RESPONSE TO AN BORD PLEANÁLA OPINION

**PROPOSED RESIDENTIAL DEVELOPMENT AT A SITE LOCATED AT CITYWEST
SHOPPING CENTRE, FORTUNESTOWN, DUBLIN 24**

Pre-Application Reference No. - ABP-304454-19

Fig. 1: Design rationale for northern blocks (Source, JFA Design Statement)

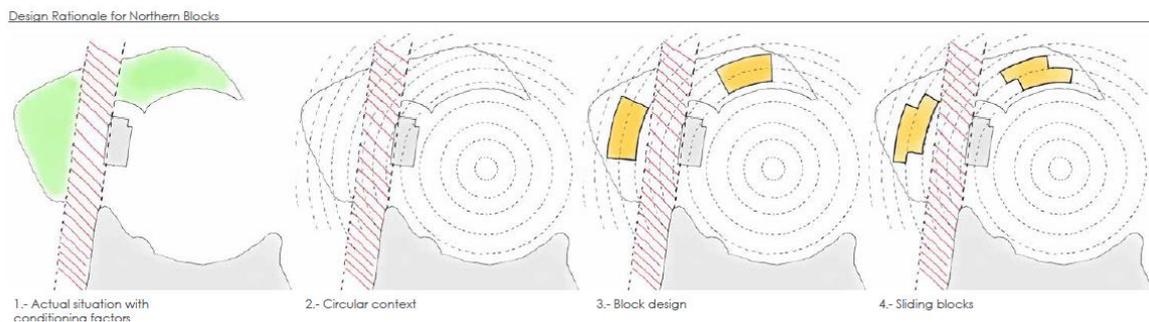
“Further consideration and/or justification of the documents as they relate to design and expression, in particular, of Block E & F. In this regard, the prospective applicant should satisfy themselves that the design strategy for the site as it relates most importantly to the designation in the development plan, as a “District Landmark”, is the optimal architectural solution for this strategic gateway site. The proposed development shall have regard to inter alia, national policy including the 12 criteria set out in the Urban Design Manual which accompanies the Guidelines for Planning Authorities on Sustainable Residential Development in Urban Areas, 2009. In this regard further consideration is required for the design and configuration of the layout particularly in respect of the nature and scale of the built form, the use of external materials which respects the receiving environment and the orientation of blocks as they address the Fortunestown Lane, the junction of Fortunestown lane and City West Road and the existing commercial development on the associated land holding. Further consideration of these issues may require an amendment to the documents and/ or design proposals submitted”.

In response to the comments received with regard to Blocks E and F, the design team reconsidered the approach to the development of the northern portion of the site. The presence of the Irish Water wayleave, which bisects this part of the site necessitated the retention of two separation building blocks, however the architectural design and form of these blocks was amended in order to more appropriately respond to the landmark status of the site as required by the Fortunestown LAP.

The proposed apartment blocks are now presented in a curved formation which mirrors the façade of the Citywest Shopping Centre to the immediate south of the blocks. In order to add visual interest and to contribute to the landmark status of the site, the architect has introduced the concept of ‘sliding blocks’ which will provide a memorable architectural form at this prominent location.

Fig. 3: Site Access Strategy (Source: Traffic and Transport Assessment, p. 33, DBFL)

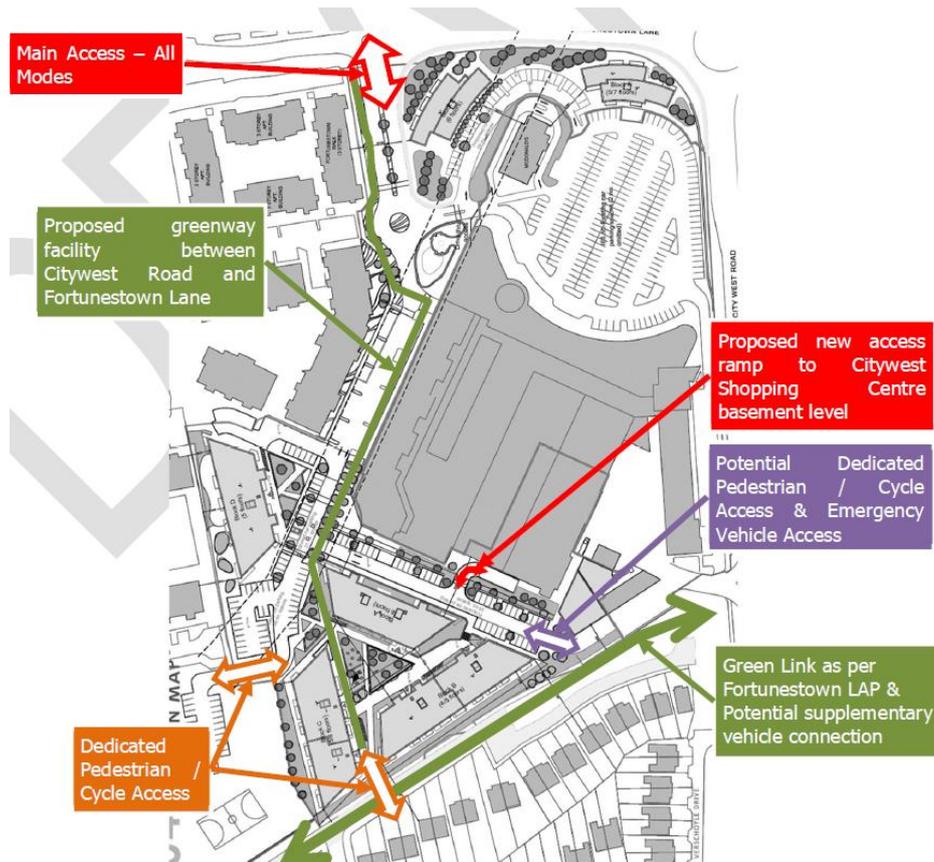
"Further consideration and/or justification for a reduction in the provision of surface car parking, integration of high quality pedestrian and cycle through routes, enhanced with landscaping. In light of any reduction in surface car parking and/or provision of alternatives, further consideration and/or justification for a second vehicular access through the site from Citywest Road, will be provided for in any Traffic Impact Assessment".

Car parking was also reduced in order to allow additional space for the provision of two high quality green links within the site as requested during the pre-application consultation process. A green link comprising a mix of dedicated cycle lanes and pedestrian footpaths, in addition to cycle and pedestrian shared surface is provided from the main entrance to the scheme on Fortunestown Lane, and from the secondary entrance on Citywest Road. These green links both provide easy access through the site towards the District Park. Further information regarding the nature of the green links is provided within the *Traffic and Transport Assessment*.

As requested within the Opinion received by An Bord Pleanála, the potential need for a second vehicular access to the site was examined. The *Traffic and Transport Assessment* demonstrates that an additional full vehicular access is not required, however an additional access is proposed from Citywest Road for emergency vehicles and pedestrians / cyclists. Removable bollards will be provided at this location prohibiting all other vehicles from entering / exiting the subject development site at this location except in the event of an emergency situation which prevents access / egress via the main vehicular access on Fortunestown Lane. It is not considered appropriate that this access be permanently open as this may lead to motorists taking a short cut through the residential scheme to access Fortunestown Lane.
